STATE OF TENNESSEE
DEPARTMENT OF TRANSPORTATION
BUREAU OF ENGINEERING

I-65 INTERCHANGE AT BUCKNER ROAD
IN SPRING HILL (DESIGN-BUILD)

REV. 09/14/20: REVISED INDEX OF SHEETS.

TYPE	YEAR	PROJECT NO.	SHEET NO.
FUNCT.	2020		10

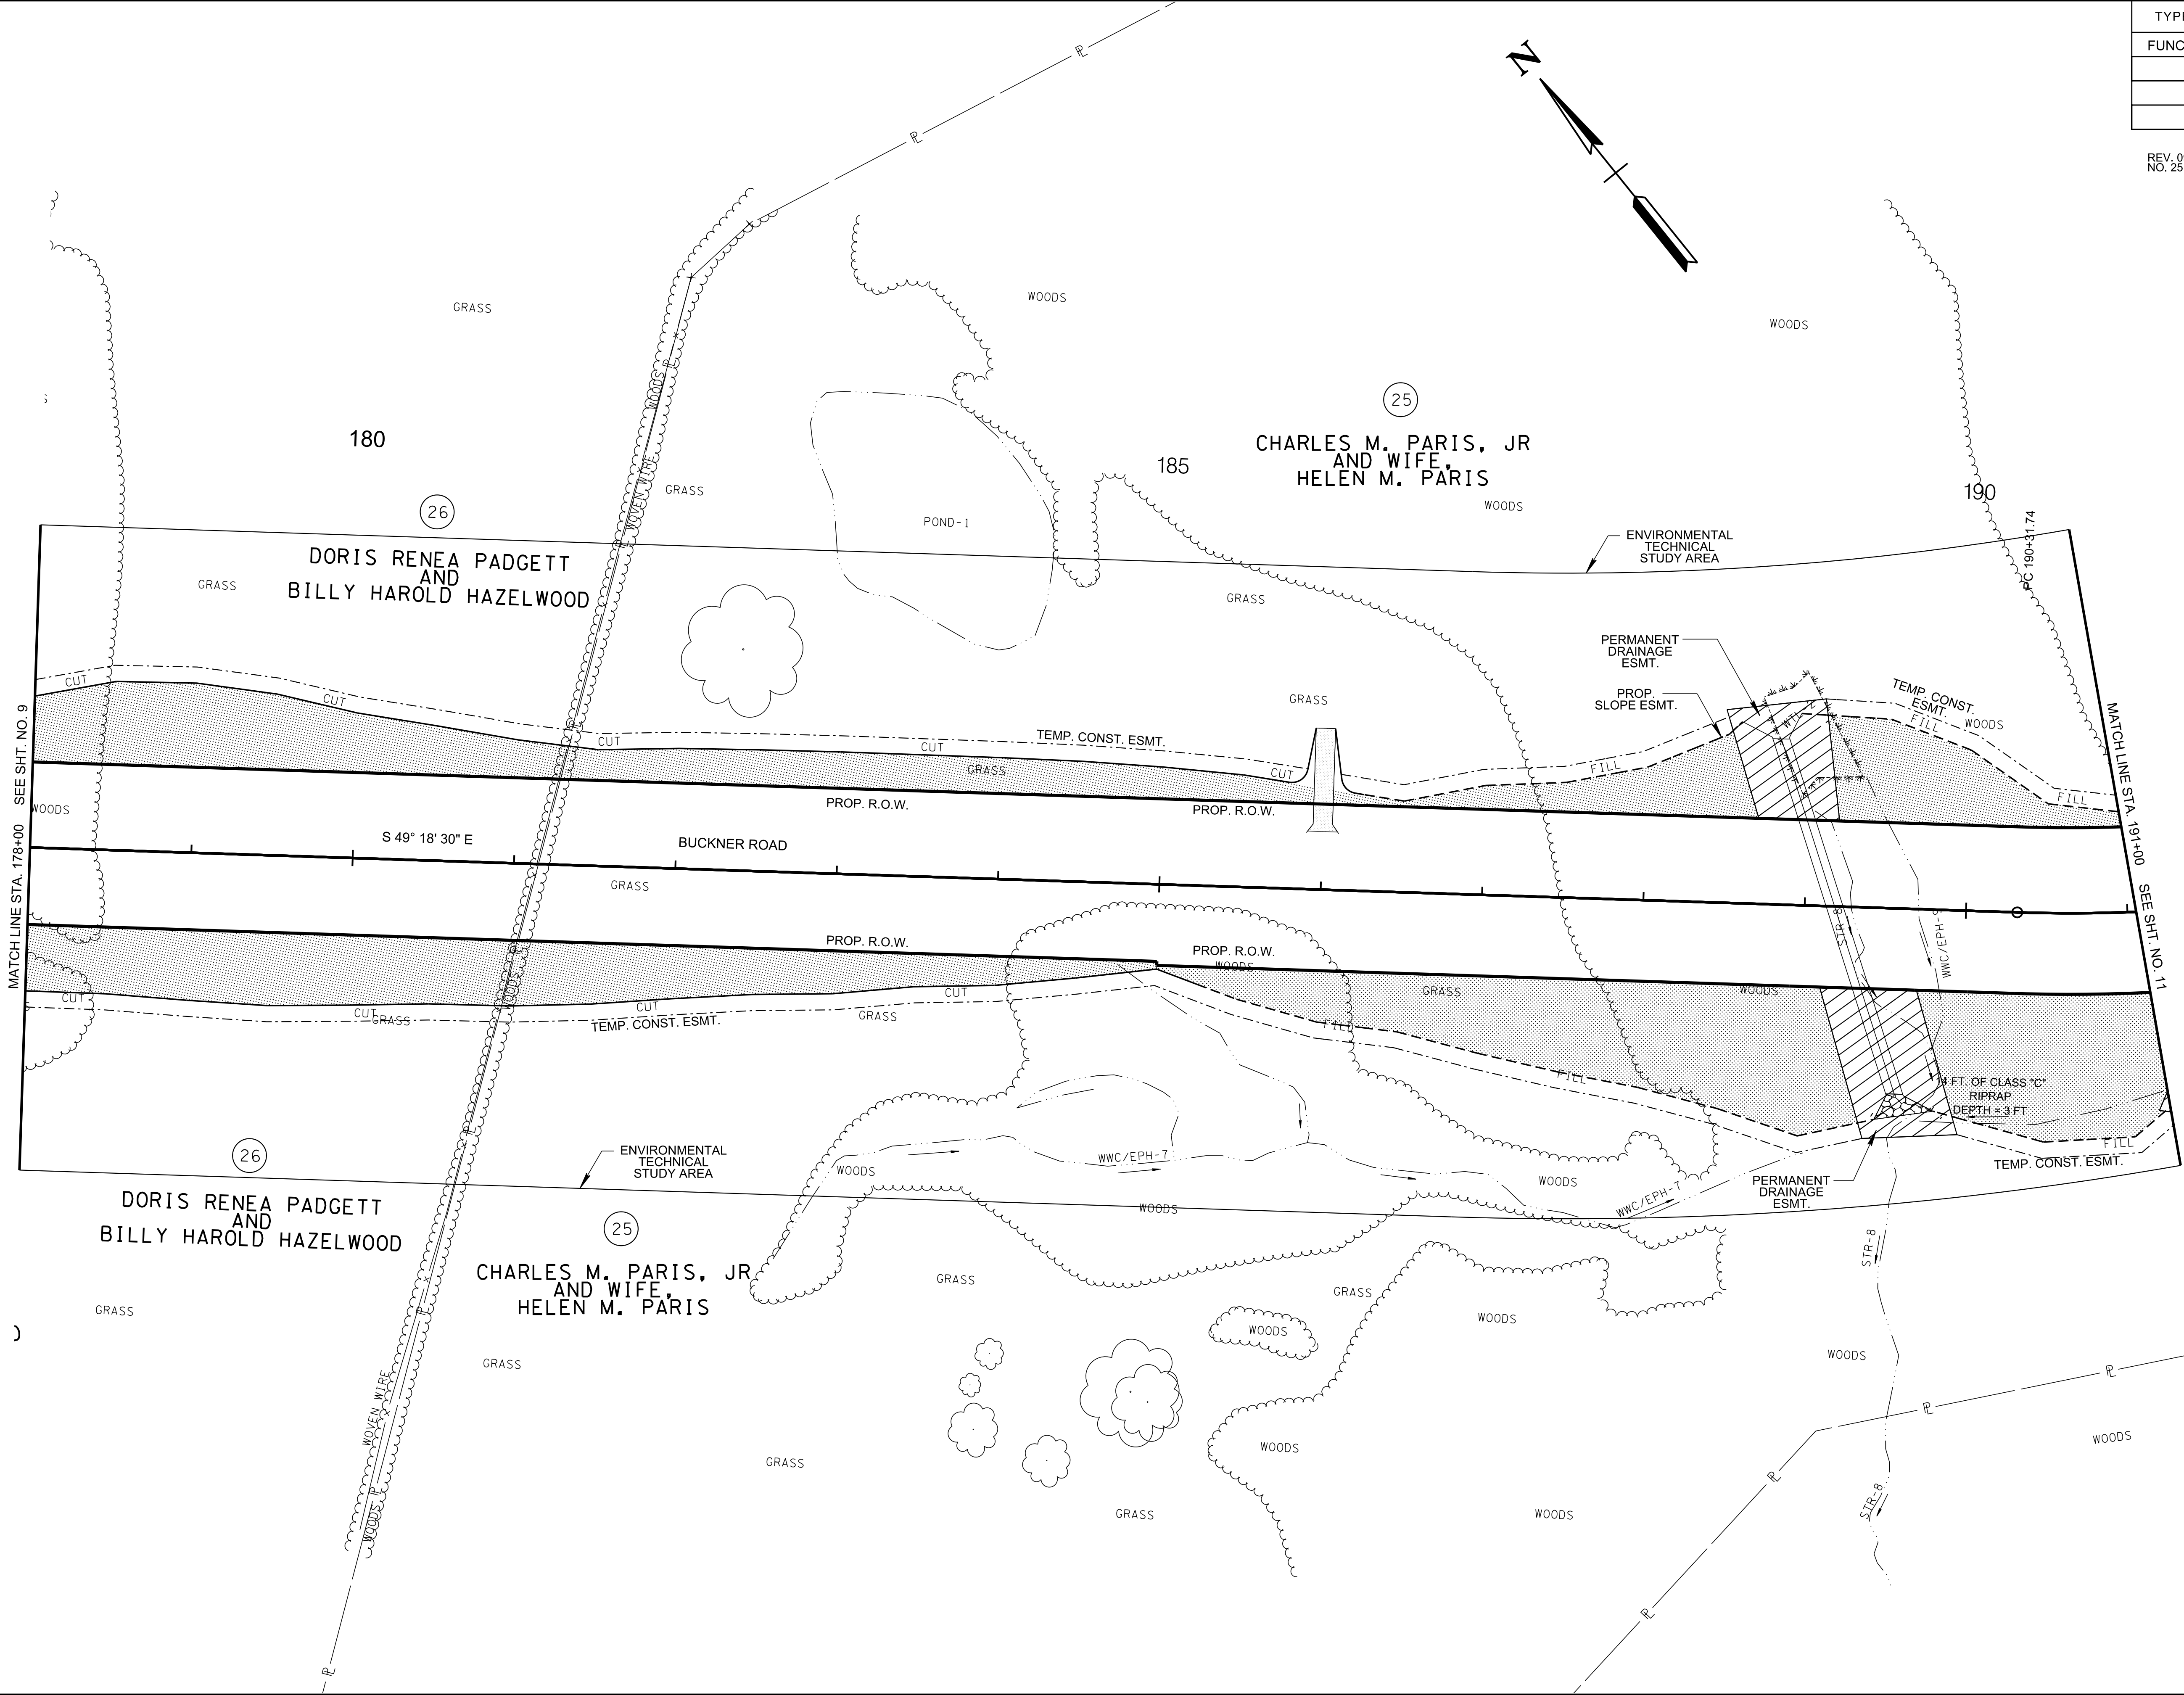
REV. 09/14/20: ADDED FIELD ENTRANCE FOR TRACT NO. 25. REVISED 10'X6' RCBC AT STA. 189+18.53.

TYPE	YEAR	PROJECT NO.	SHEET NO.
FUNCT.	2020		10A

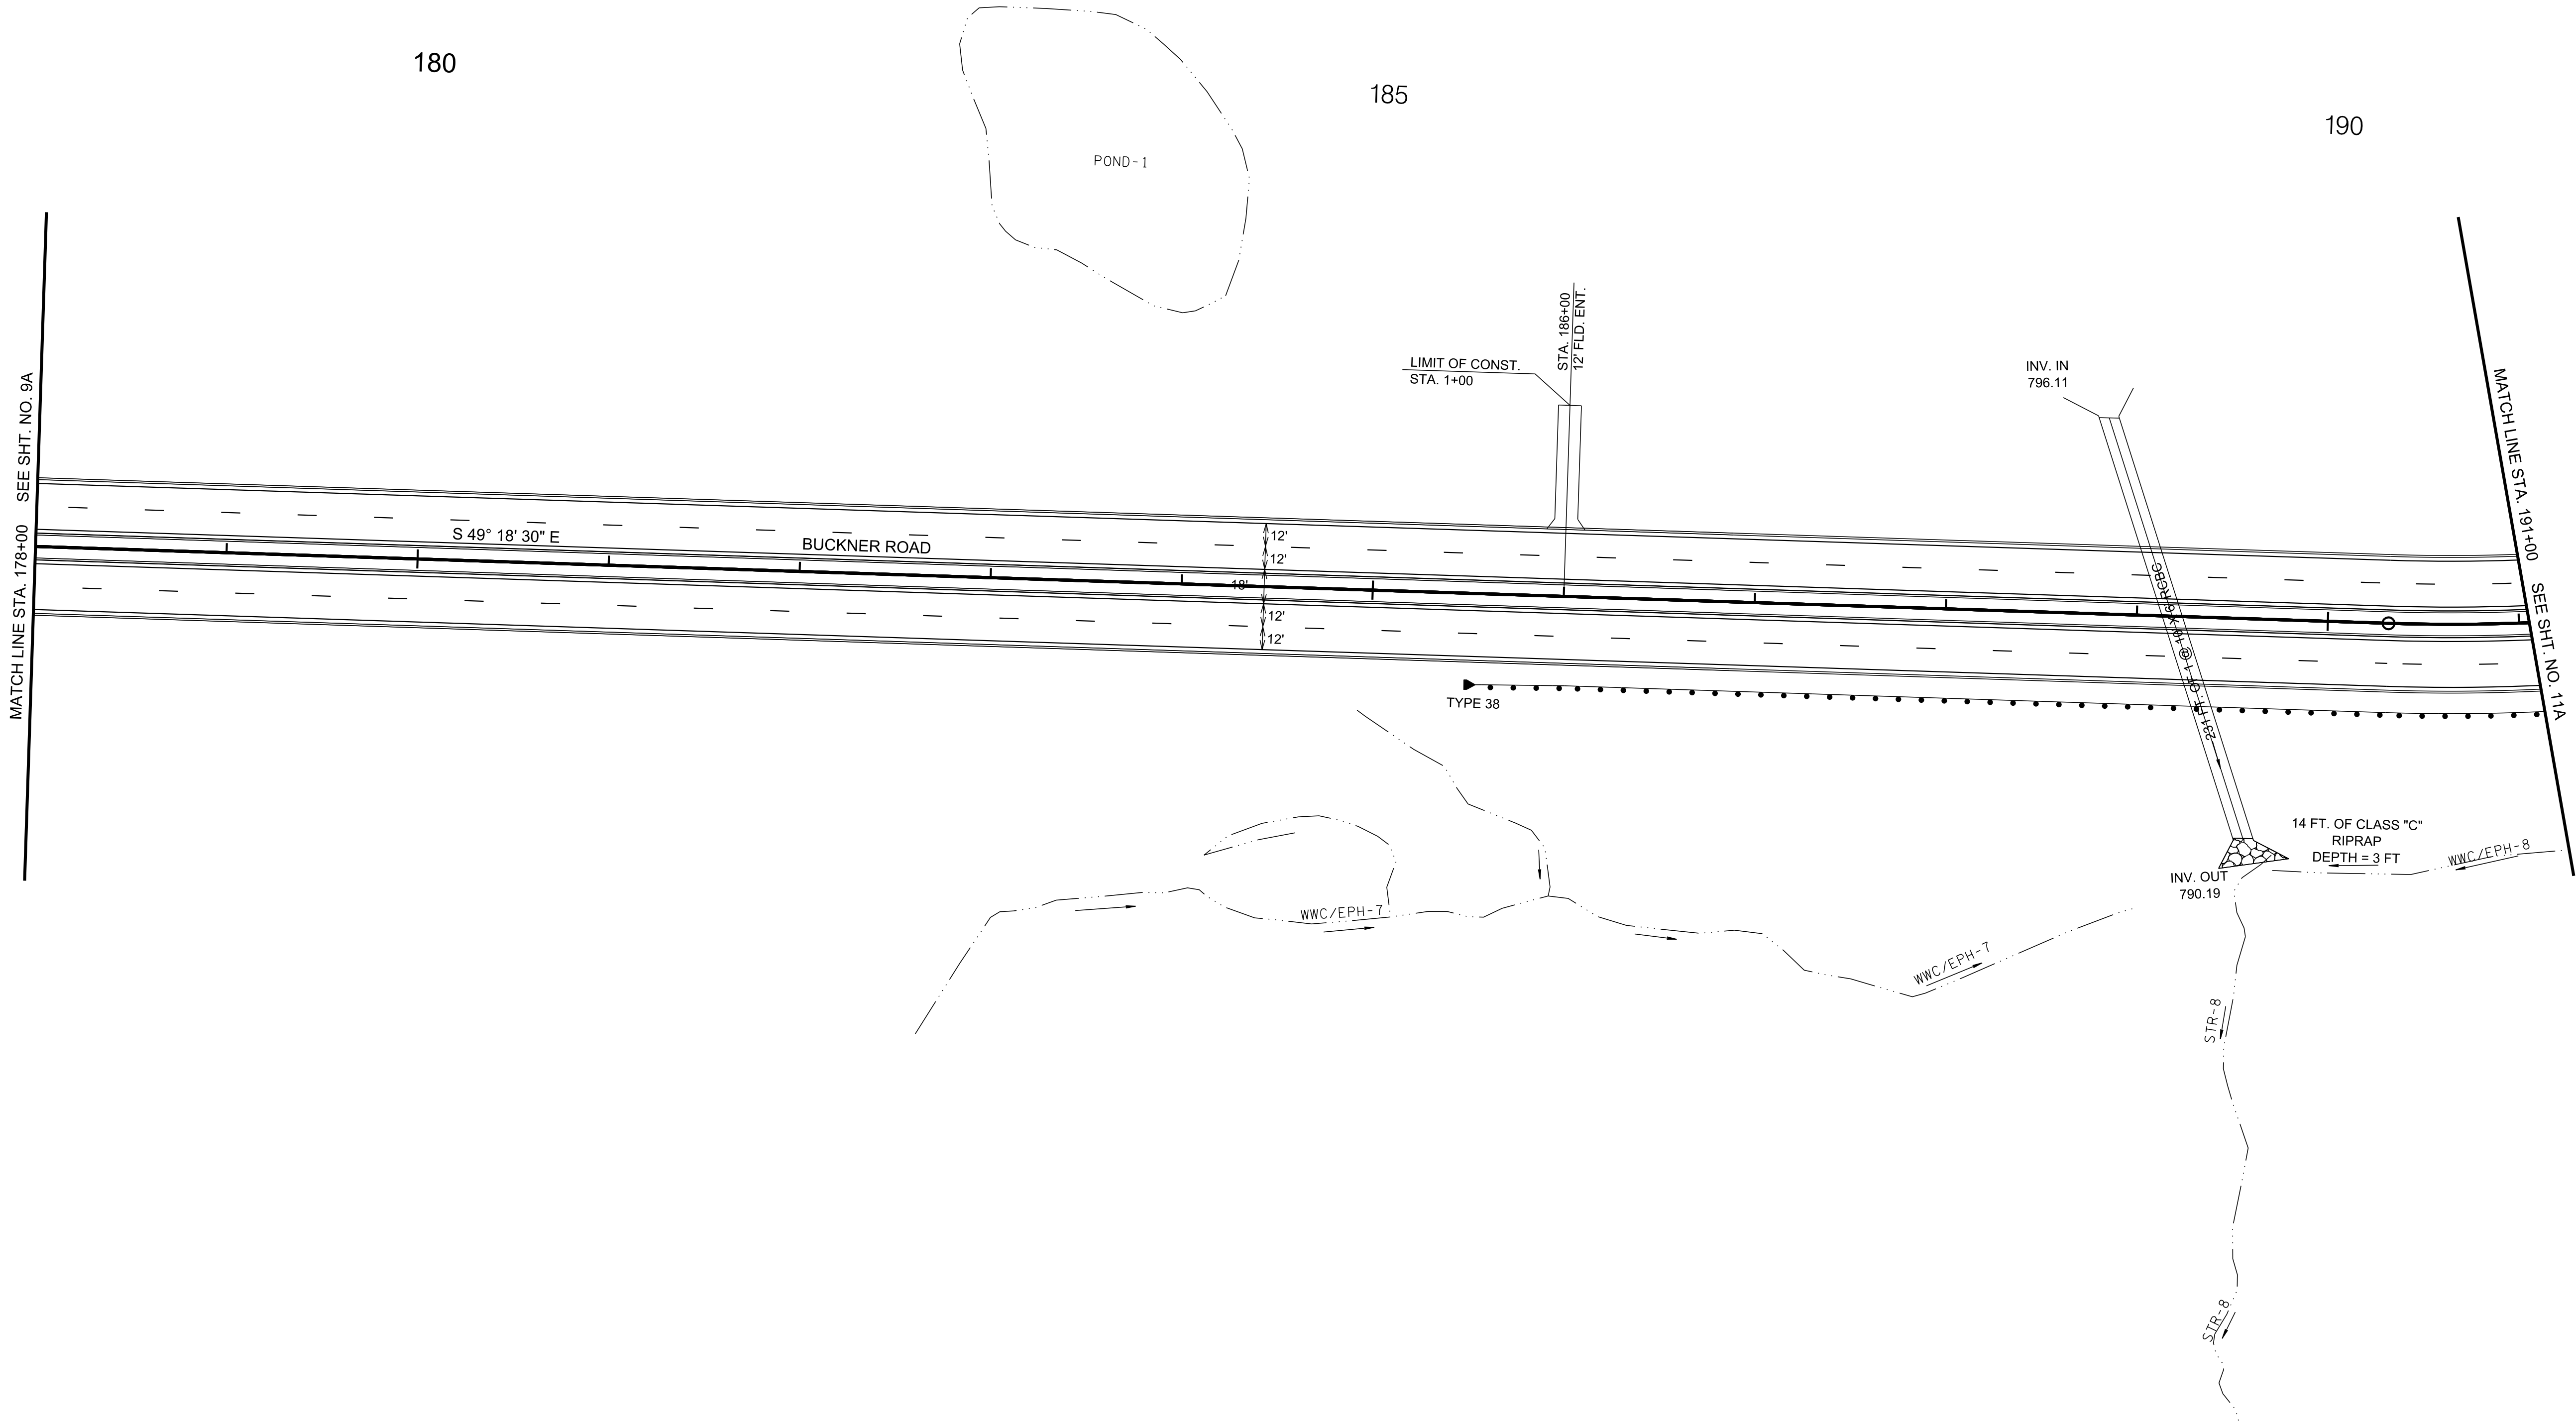
REV. 09/14/20: ADDED FIELD ENTRANCE FOR TRACT NO. 25. REVISED 10'X6' RCBC AT STA. 189+18.53 AND REVISED GUARDRAIL.

TYPE	YEAR	PROJECT NO.	SHEET NO.
FUNCT.	2020		11

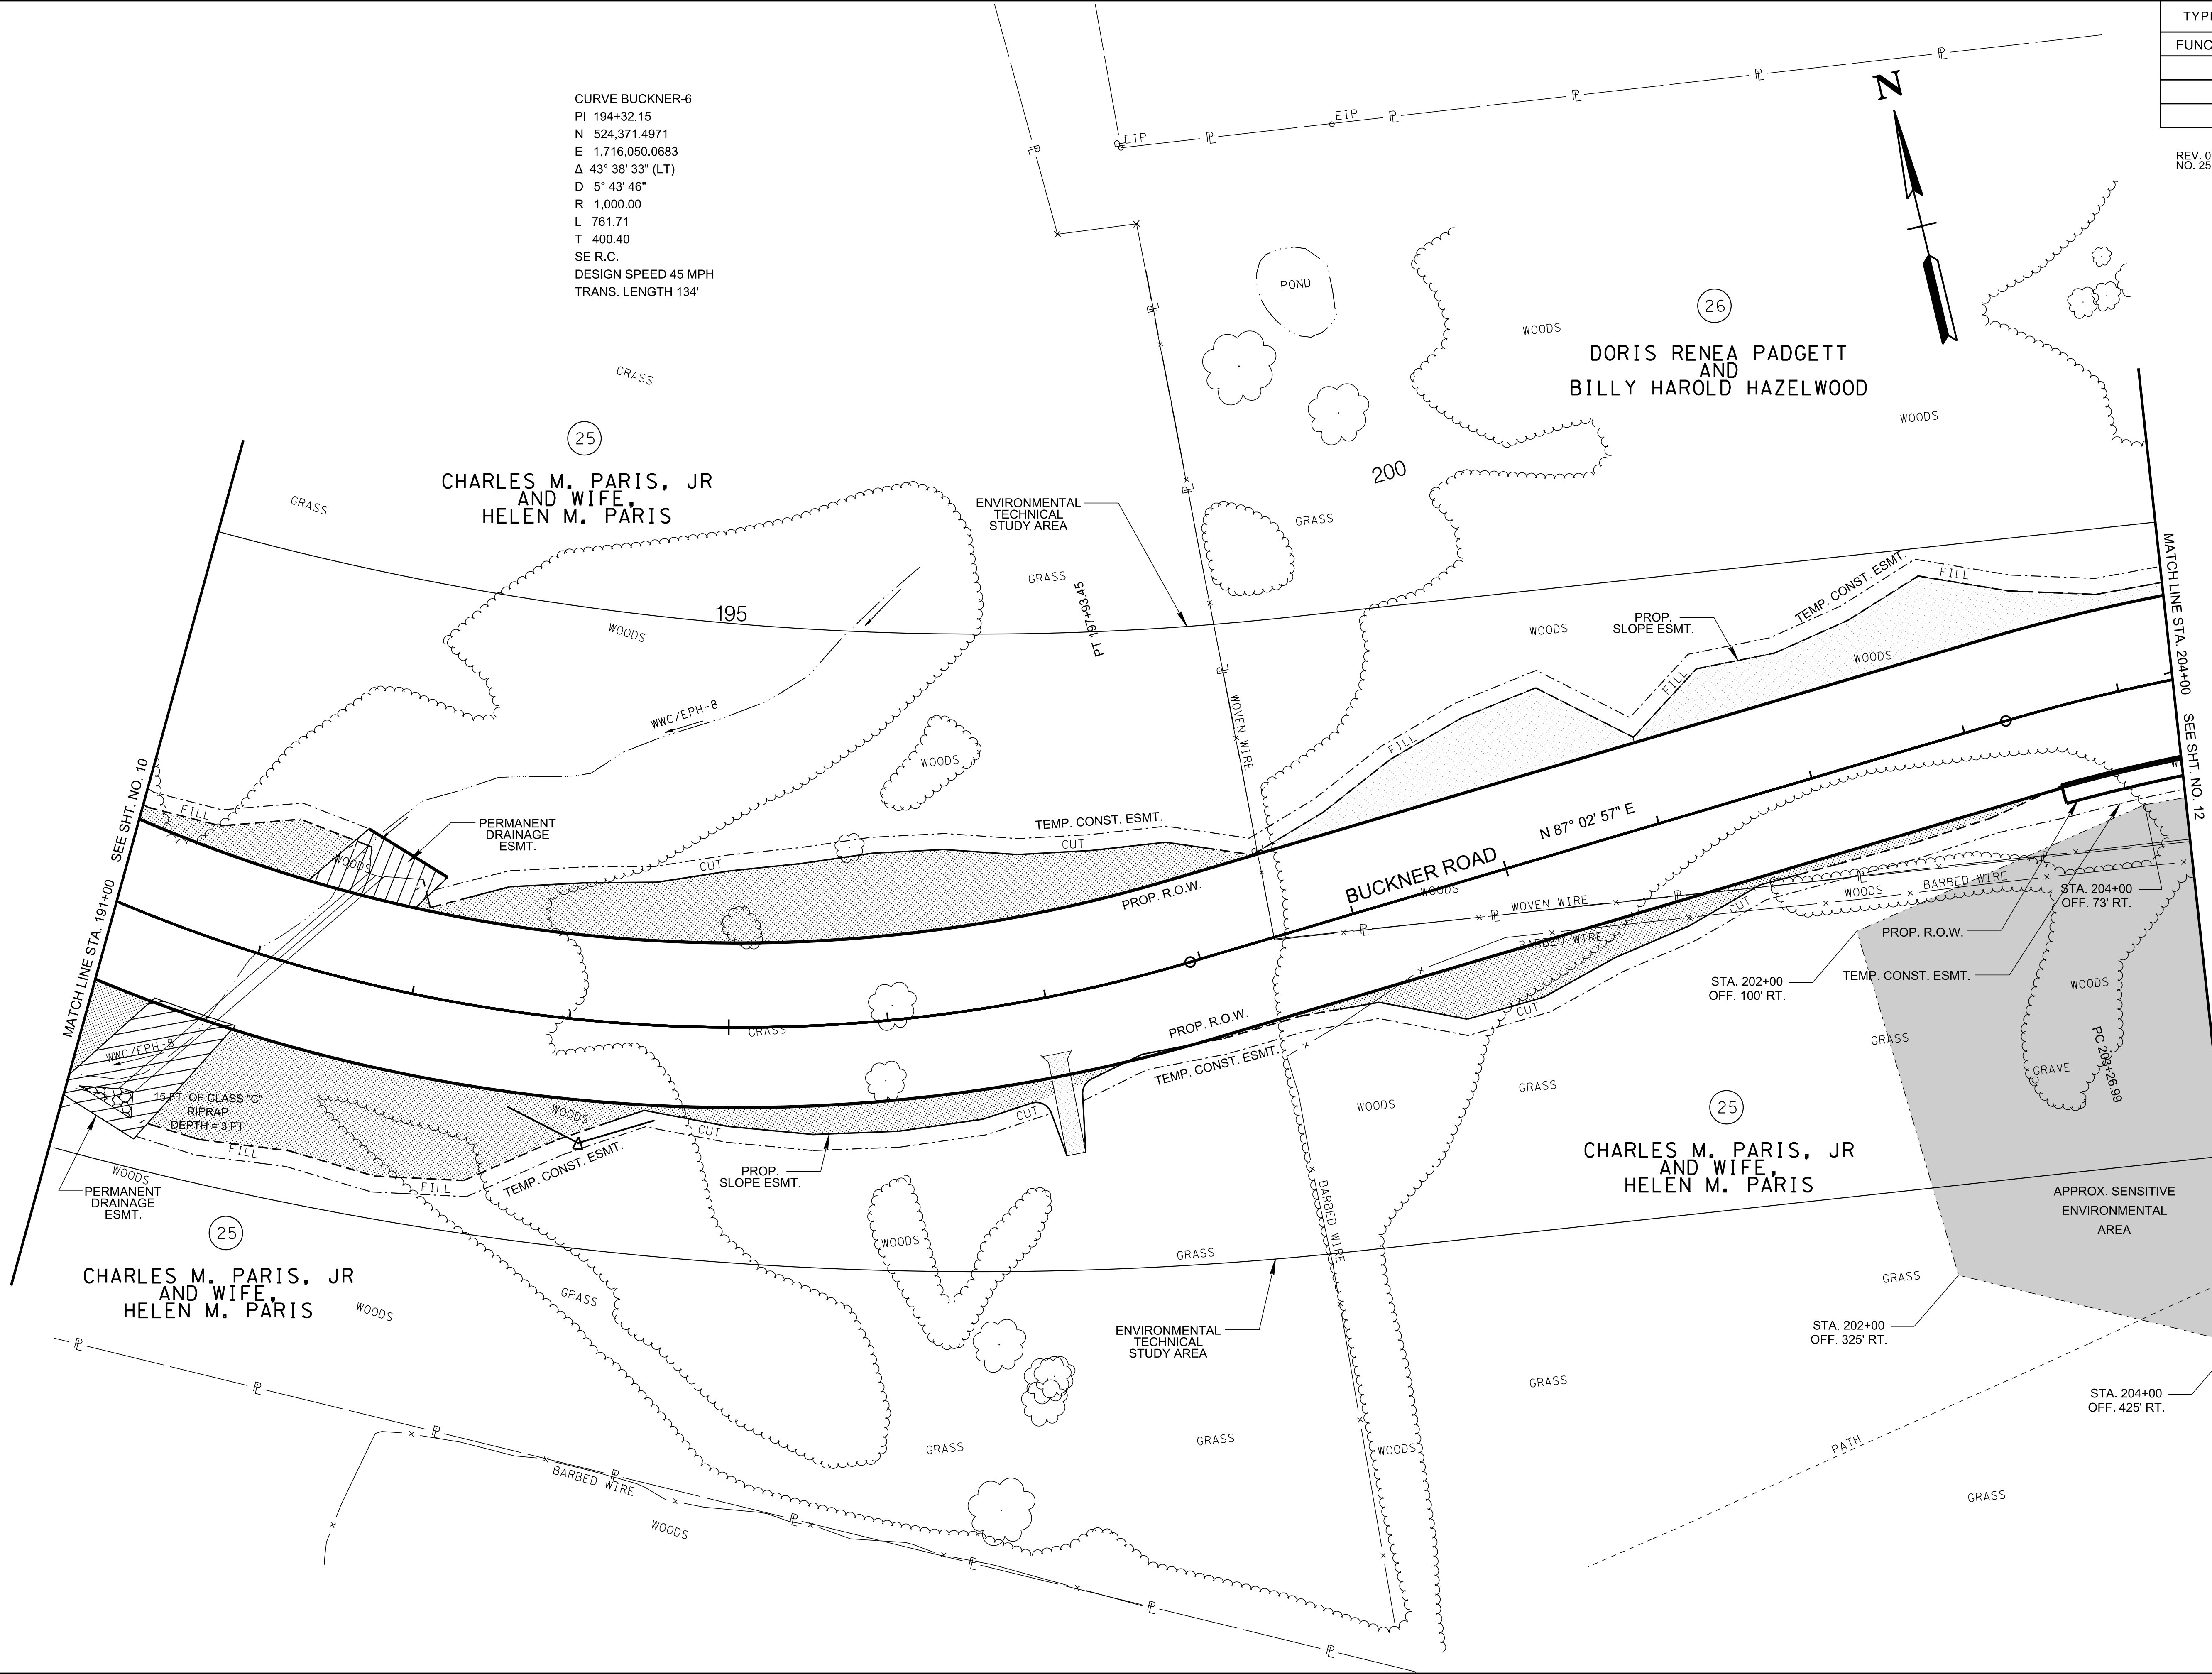
REV. 09/14/20: ADDED FIELD ENTRANCE FOR TRACT NO. 25. REVISED 8'X6' RCBC AT STA. 192+13.13.
